January 22, 2024

Re: Hamilton-Wenham Regional High School Athletic Campus Redevelopment  
Site Plan Review Application and Stormwater Management Permit Application –  
Response to Comments  
Gale JN 718601

DRAWING NO.	IS2
2 OF 2

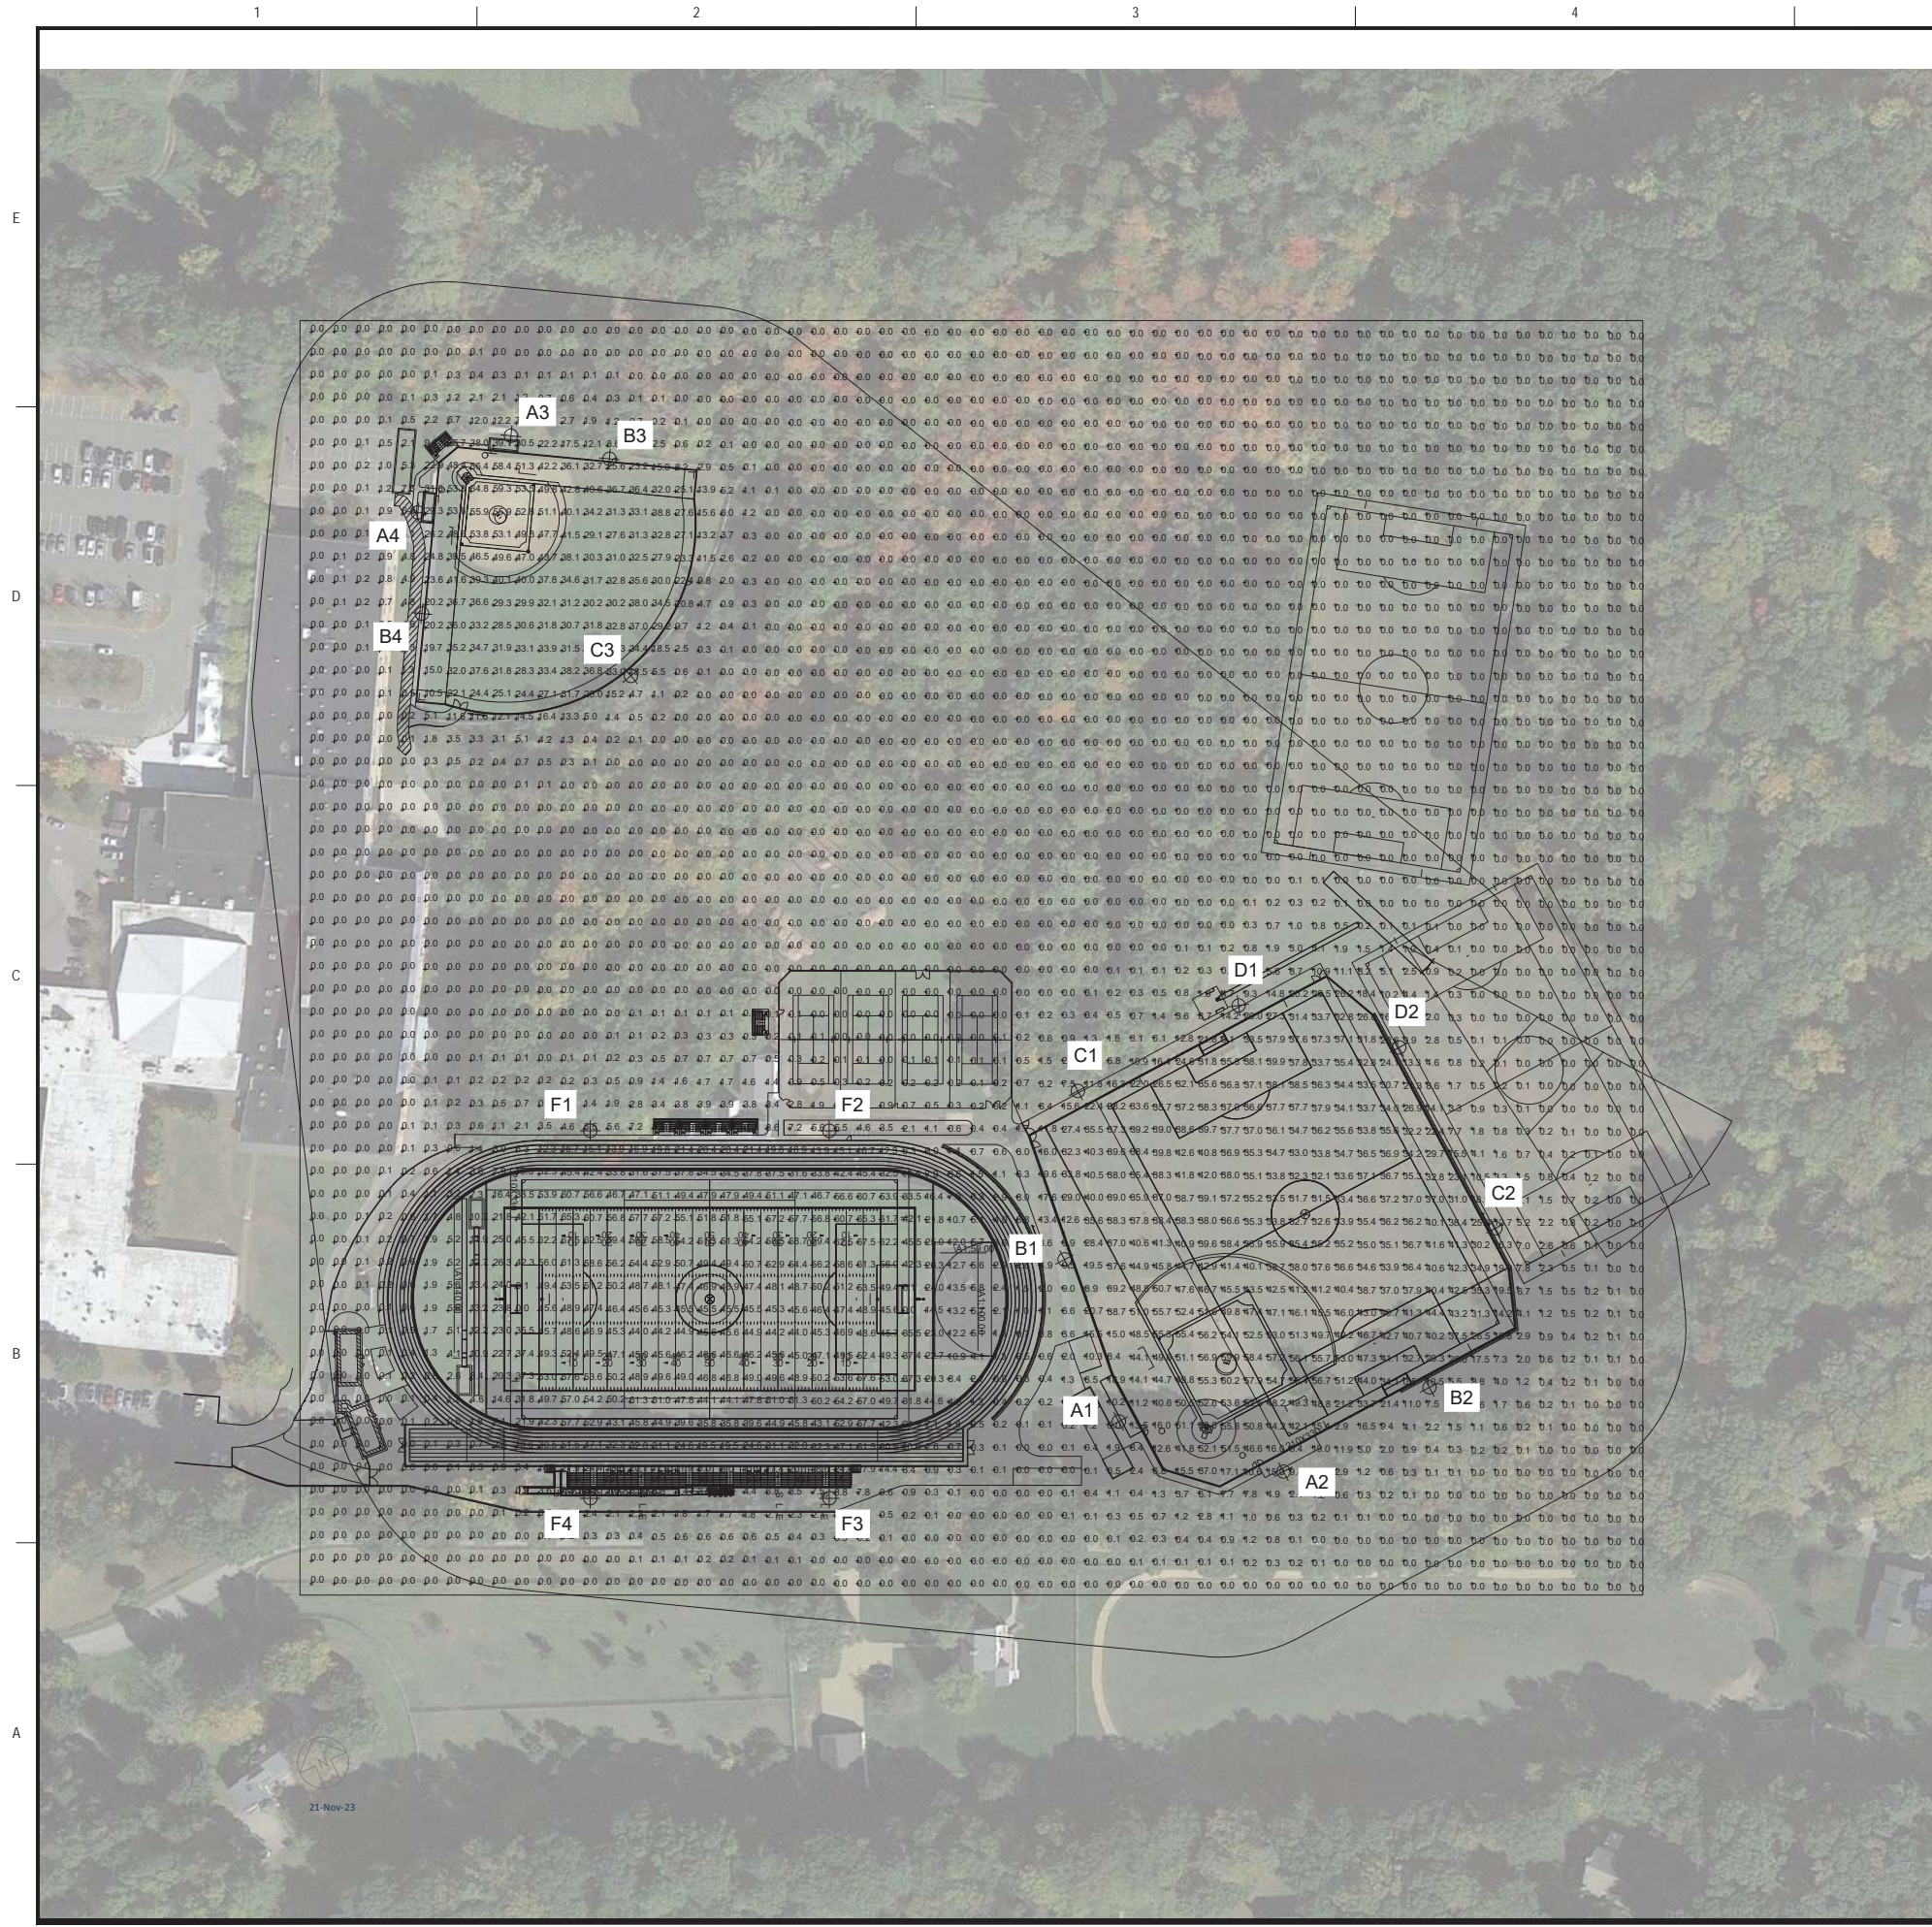
**12. Provide a complete photometric of the Athletic Campus, not just the cutoff perimeter line.**

Response: The updated photometric for the campus has been provided. Refer to updated Plan Sheets IS1 and IS2.

Typical Light Fixture with Shield

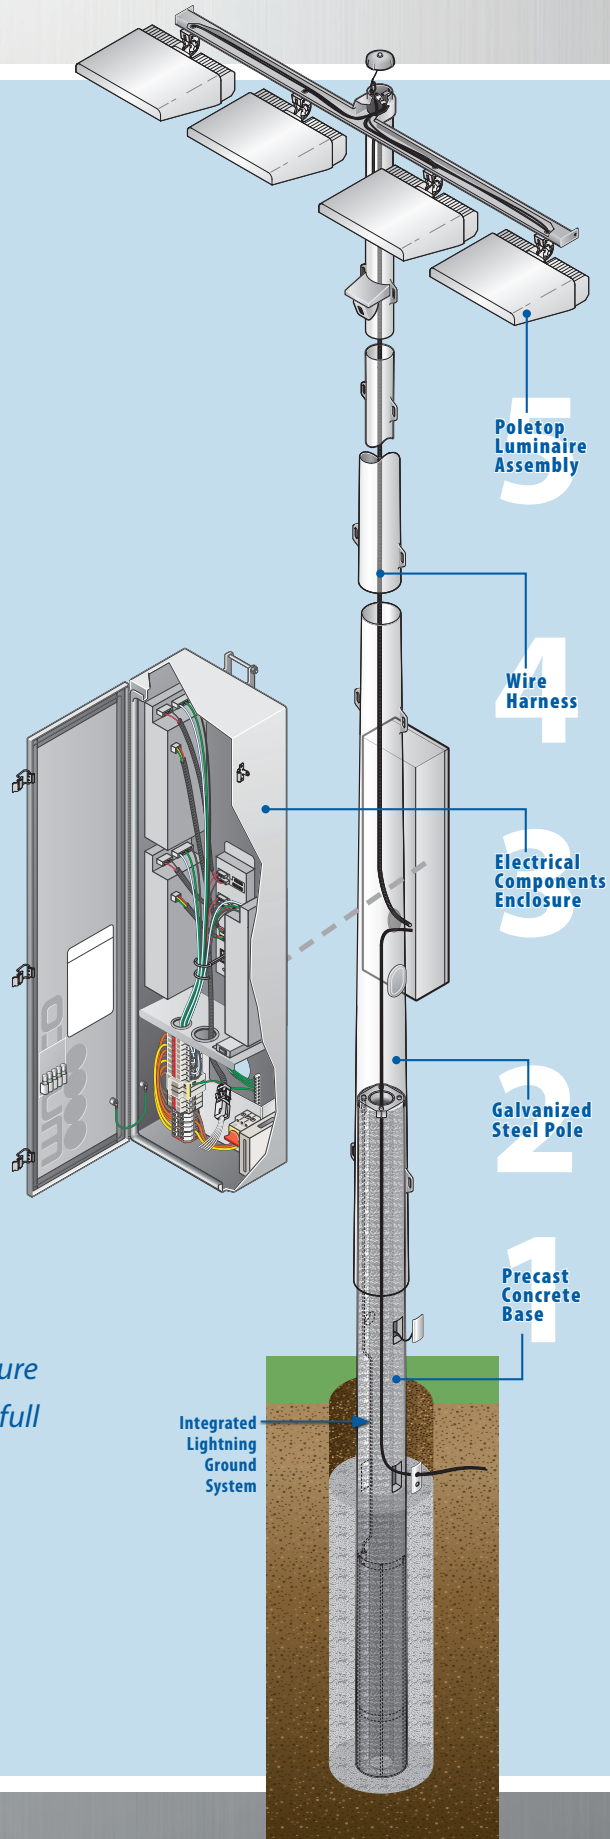
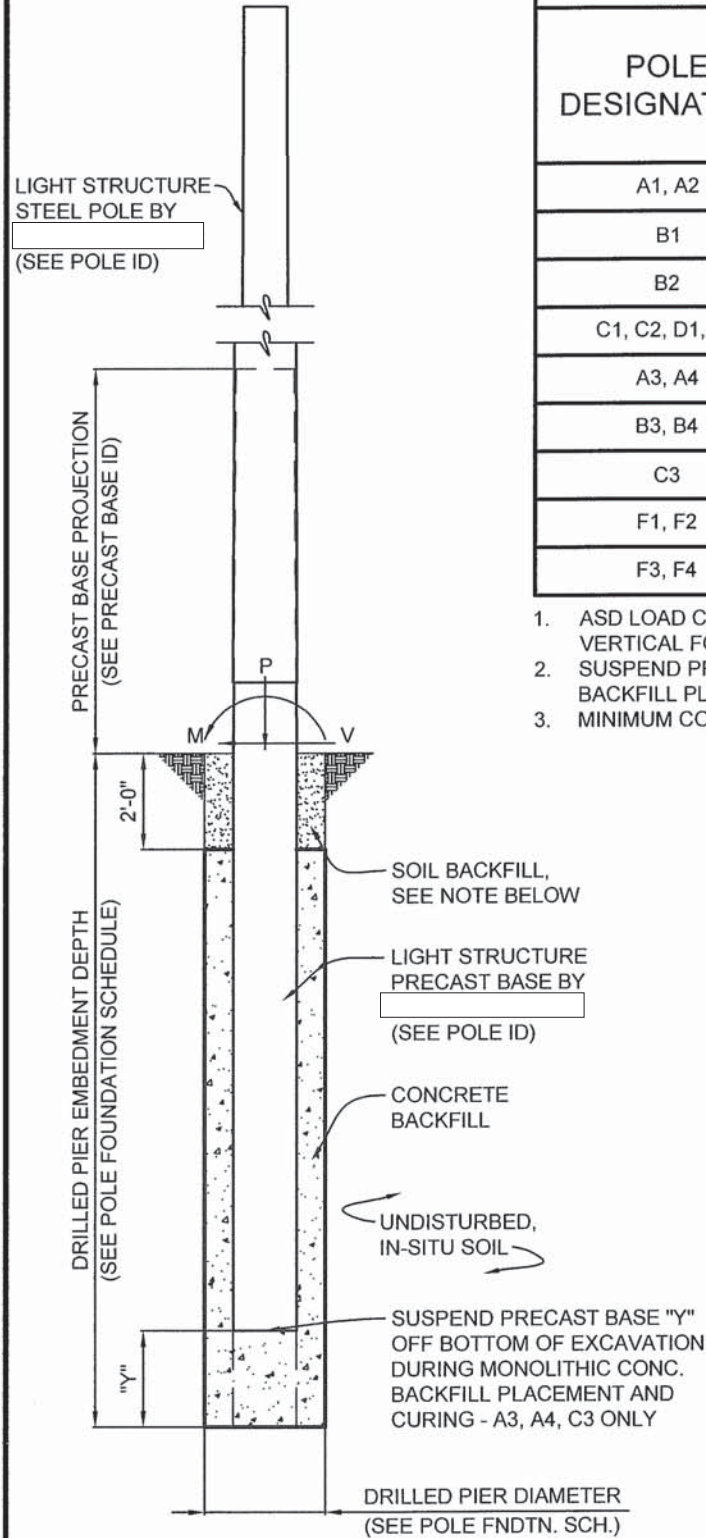
**16. Provide any possible mitigation which minimizes the visibility of lighting fixtures and point sources of light from adjacent residences.**

Response: Each of the proposed light fixtures is equipped with shields to minimize glare from adjacent residences. Refer to the Athletic Lighting Exhibits attached, including the standard light shield and Progression of Athletic Lighting.

DRAWING TITLE:  
 POLE AND FOUNDATION  
 SCALE: SEE PLAN  
 NOTES:  
 SCAN #108724D

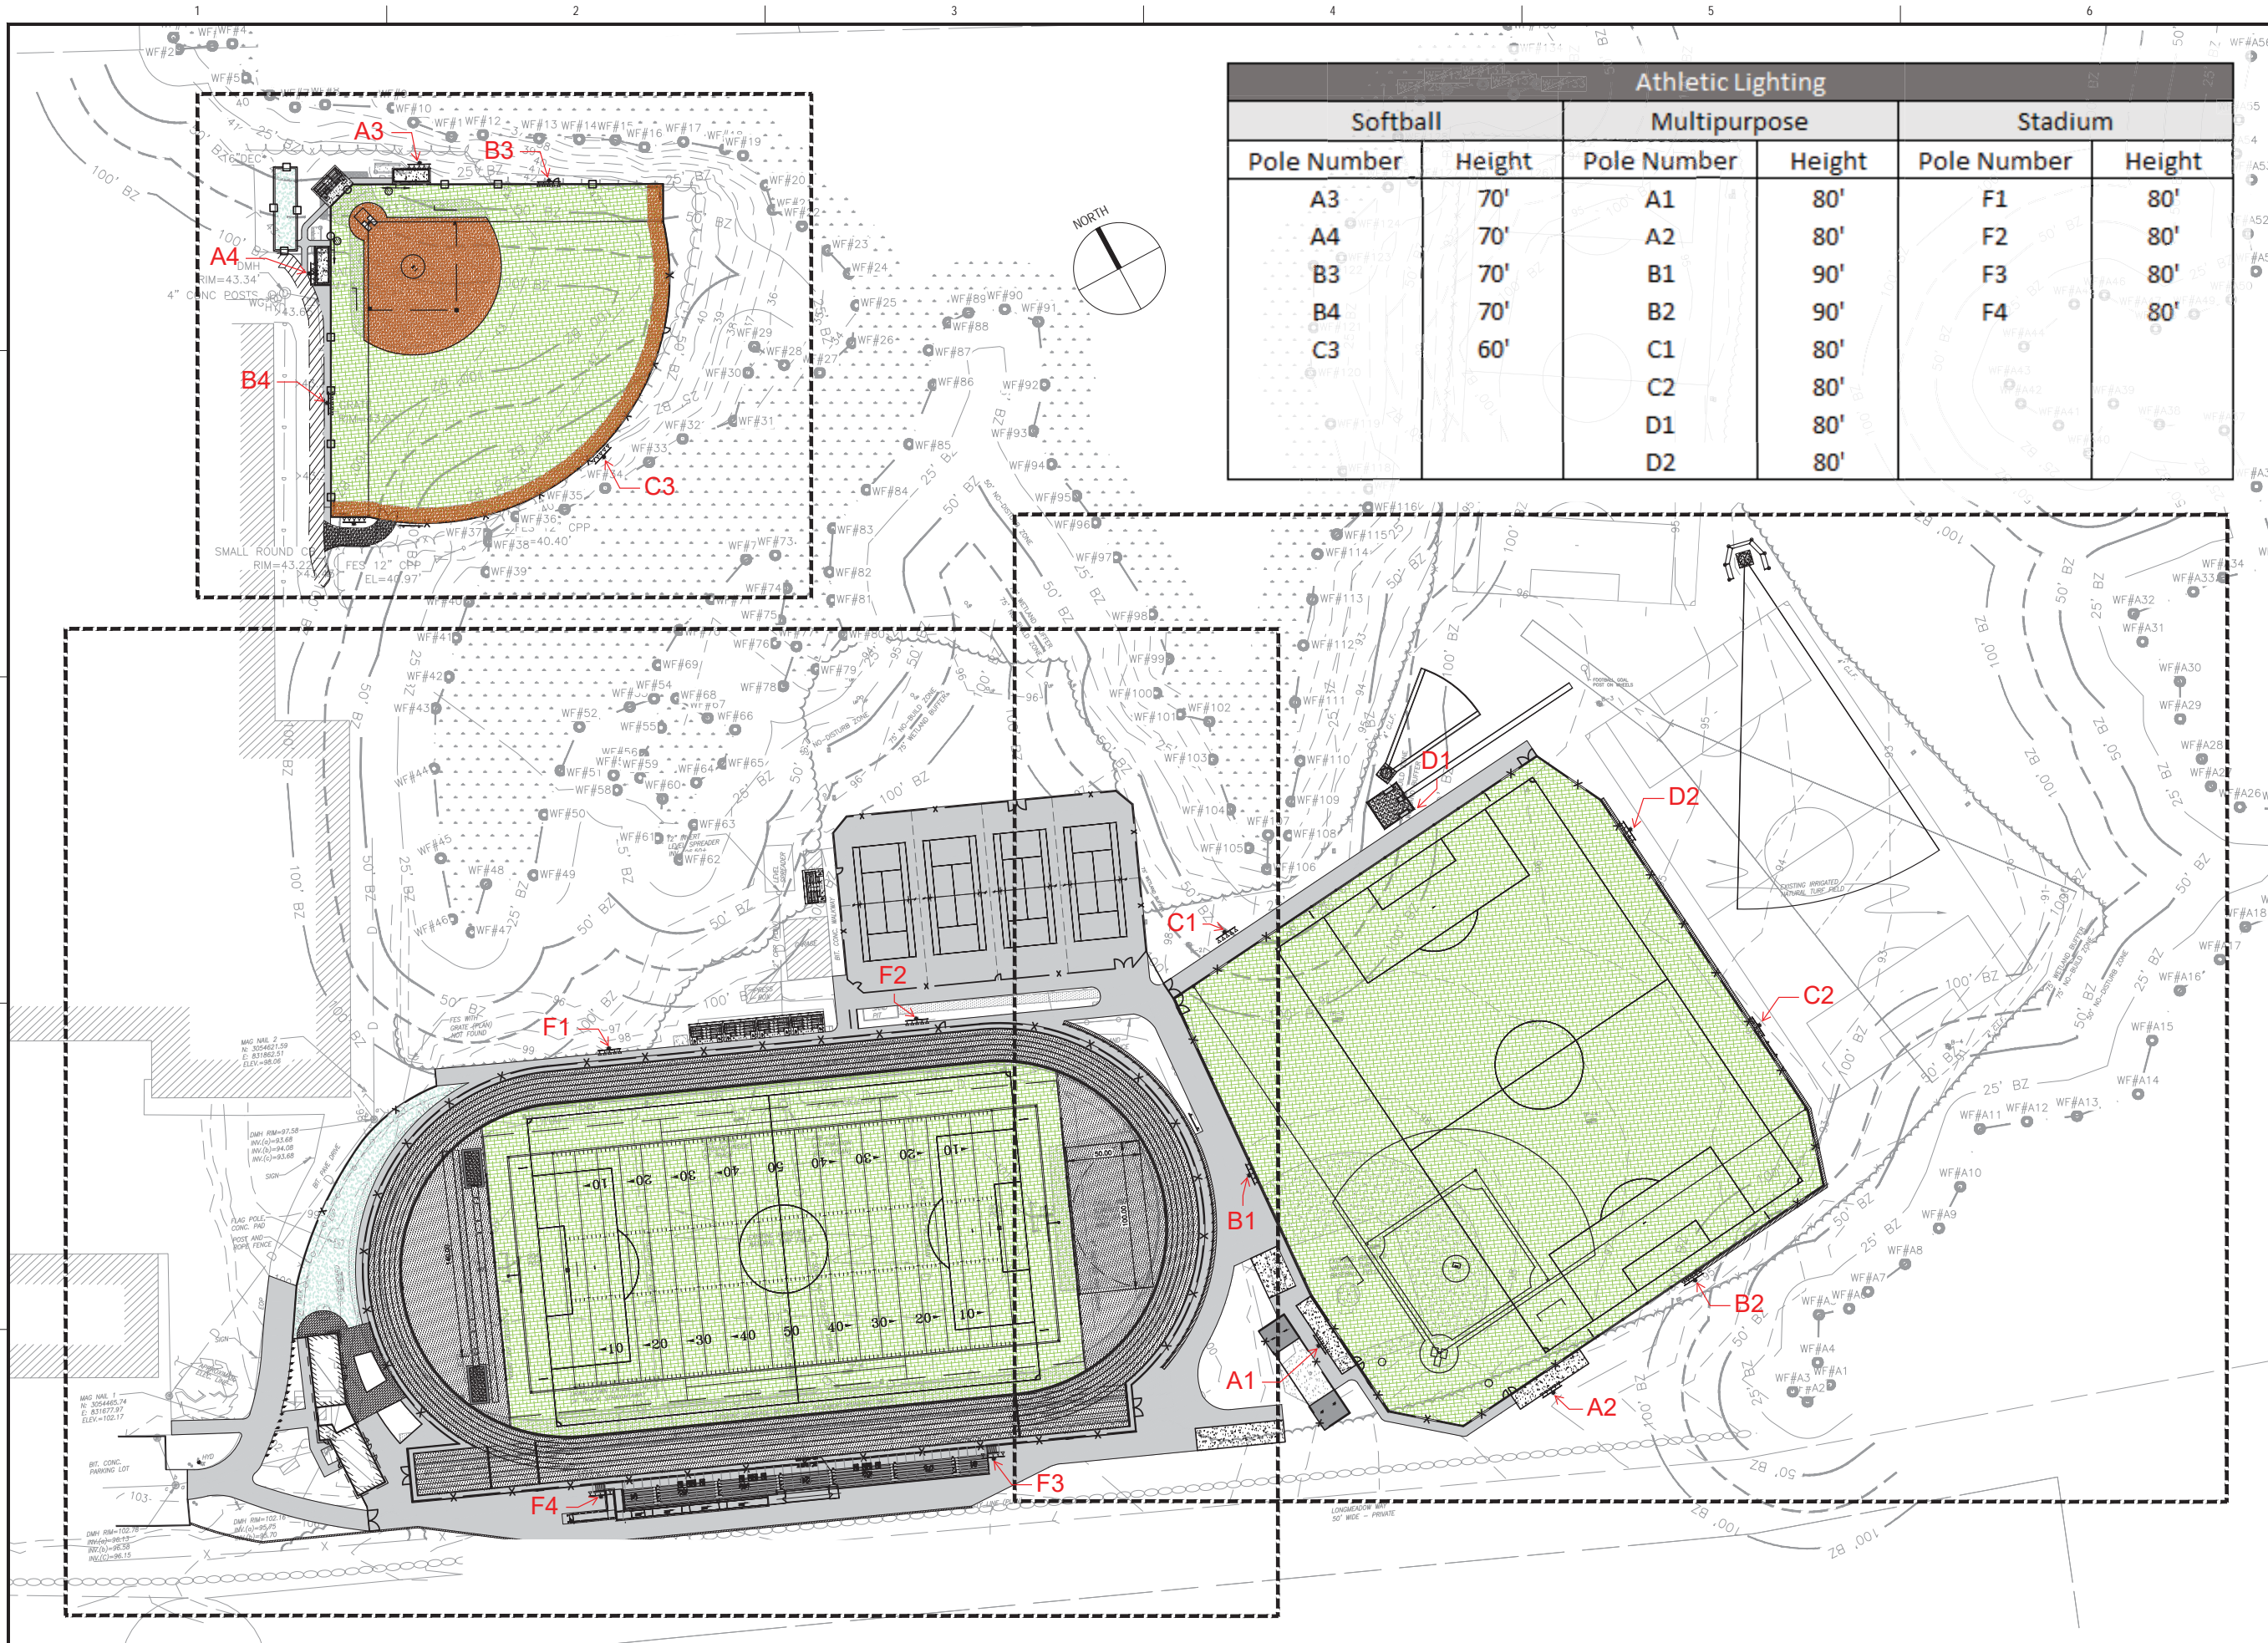
**15. Provide a light pole and pole foundation detail.**

Response: A typical light pole and pole foundation detail has been provided. Refer to the Athletic Lighting Exhibits attached.
